**BUSHFIRE**  
**CONSULTING**  
**SERVICES** PTY LTD

**Re: Lot 3 DP 805710, 181 Forest Way Belrose (subject site)**

We have been engaged by *Regis Aged Care Pty Ltd* to review the proposed minor modifications to the Court approved Seniors Housing development located at the above address.

**Figure 2: Management Zones as provided in the Biodiversity Development Assessment Report prepared by Cumberland Ecology.**

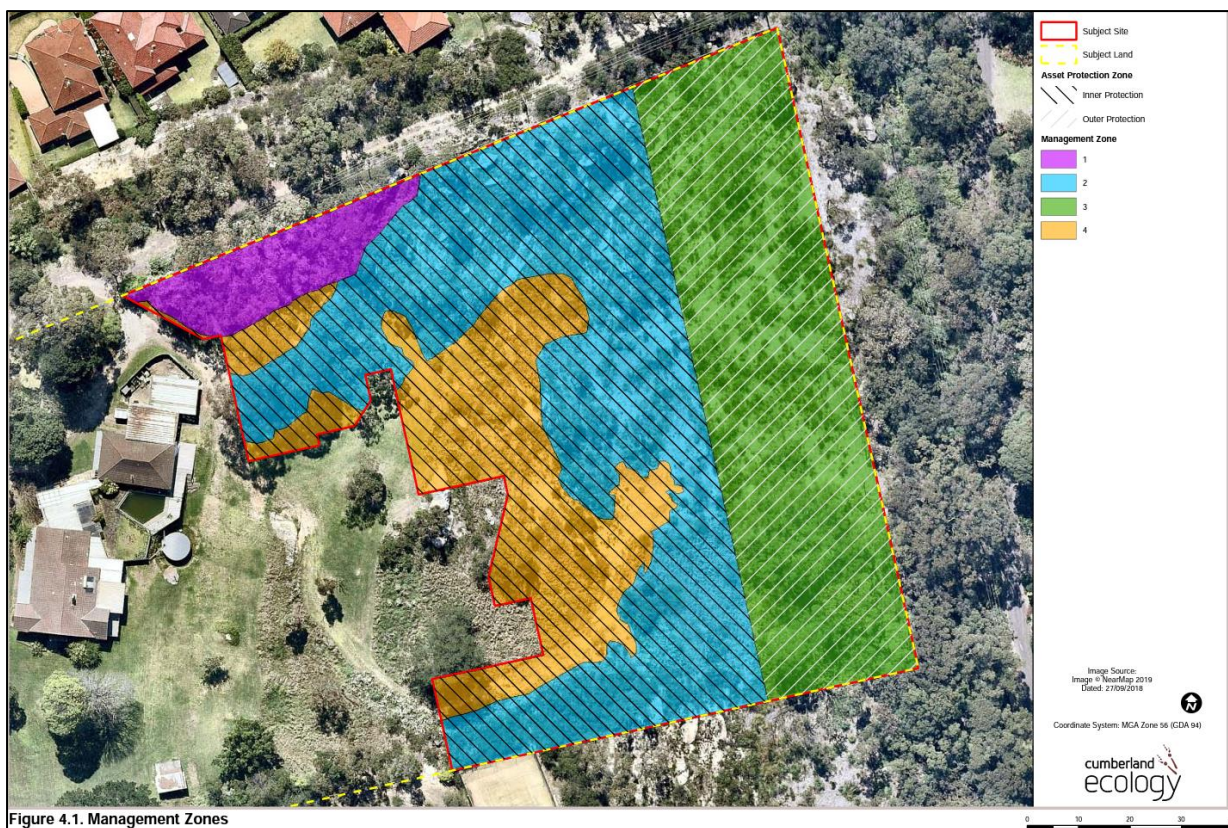
The report outlined the following management zones outside the proposed development area, noting that Zone 1 (purple) is located outside of the identified asset protection zone.

The recommended revegetation planting specifications for the subject site as outlined in the report are consistent with the requirements of an asset protection zone as follows:

**Figure 4: Current Site Plan (Morrison Design Partnership Architects. Project no. 3169, dwg no. DA050, dated 2022.04.05)**

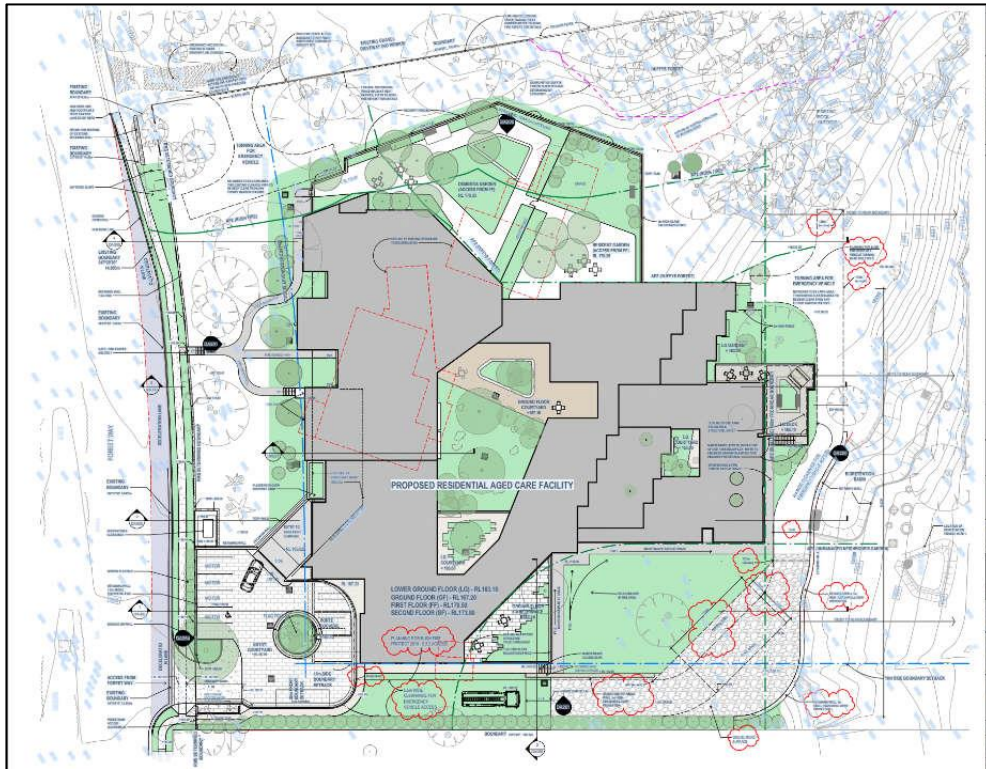
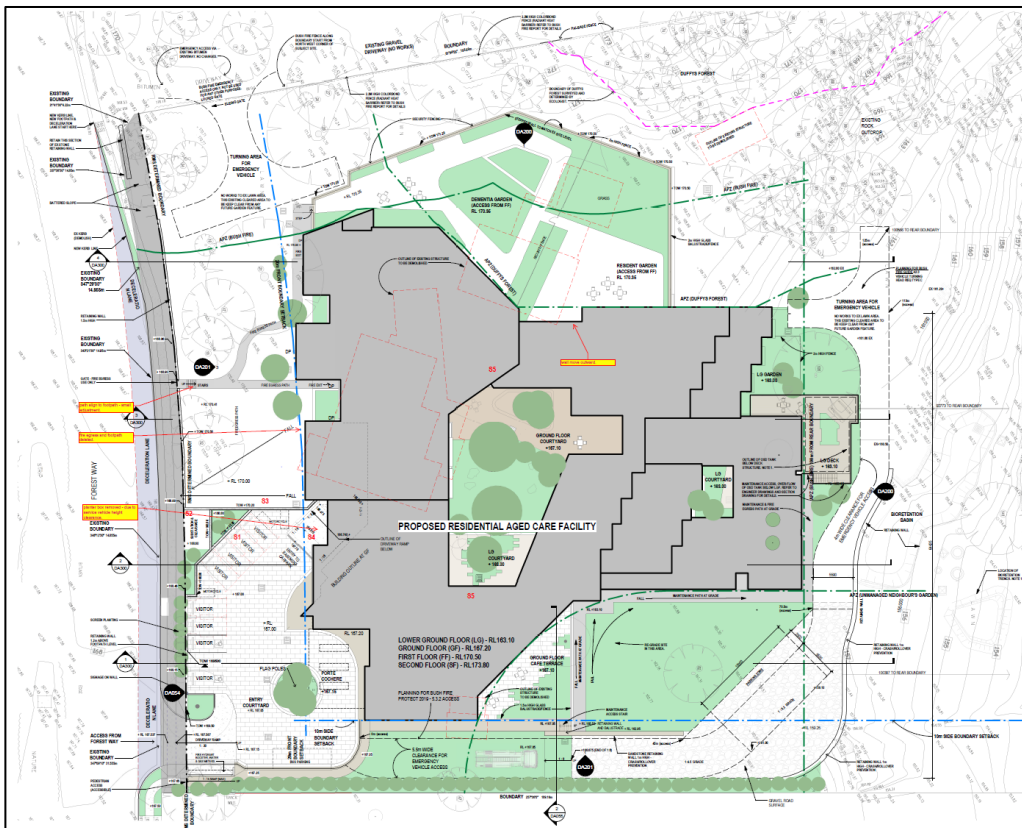
- Carpark access ramp and at grade parking within the Forest Way setback.
- Increase in car parking spaces from 45 to 49
- Lower ground floor – building footprint increases and sunken courtyard size has been reduced and location adjusted. This does not extend towards the hazard and maintains compliance with the approved APZ's
- Ground & first floor – building footprint increases towards the internal courtyard. This does not extend any closer to the hazard than adjoining walls and maintains compliance with the approved APZ's as depicted below.

As outlined above, the proposed amendment to the court approved development is minor in nature, does not encroach within the approved asset protection zone and will have no impact on the bushfire protection measures approved as part of the court approval. Suggested amendments to the bushfire safety authority are provided attached.

**Figure 5: First Floor Plan. Source: Morrison Design Partnership Architects. Project no. 3169, dwg no. DA103, Revision 0, dated 20220405**

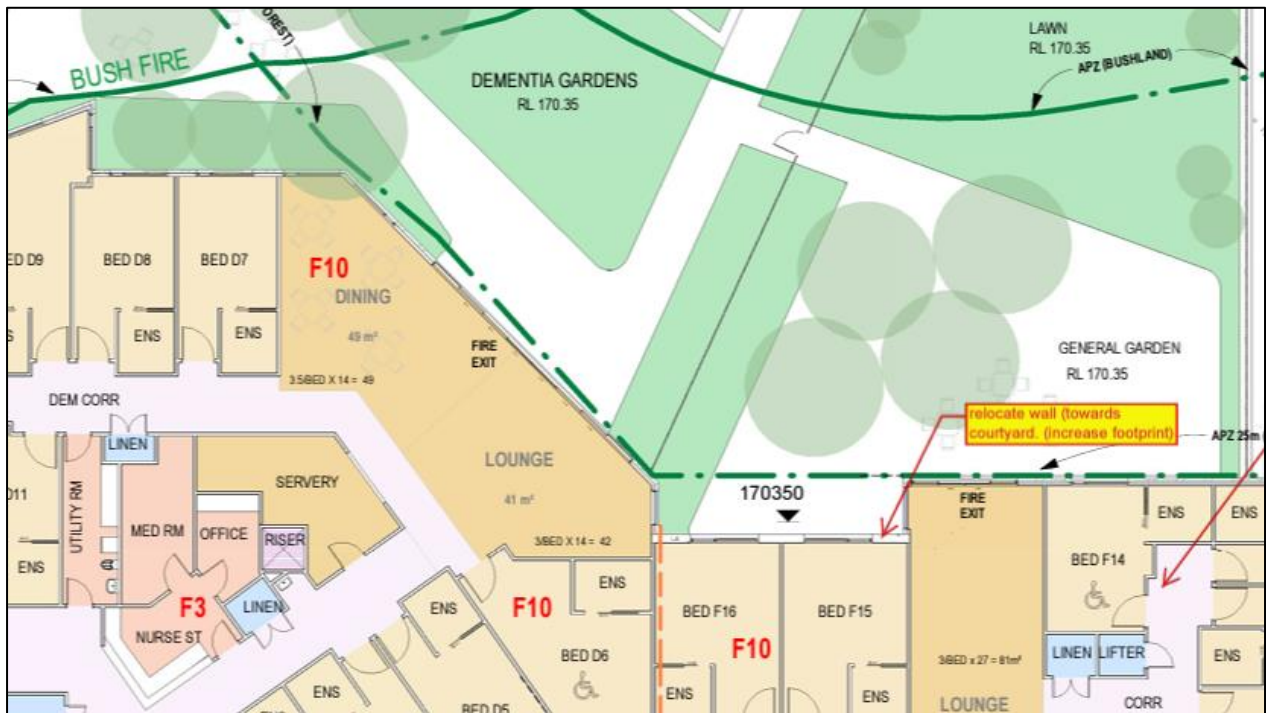
Figure showing minor amendment of footprint to the north whilst maintain compliance with APZ setbacks.
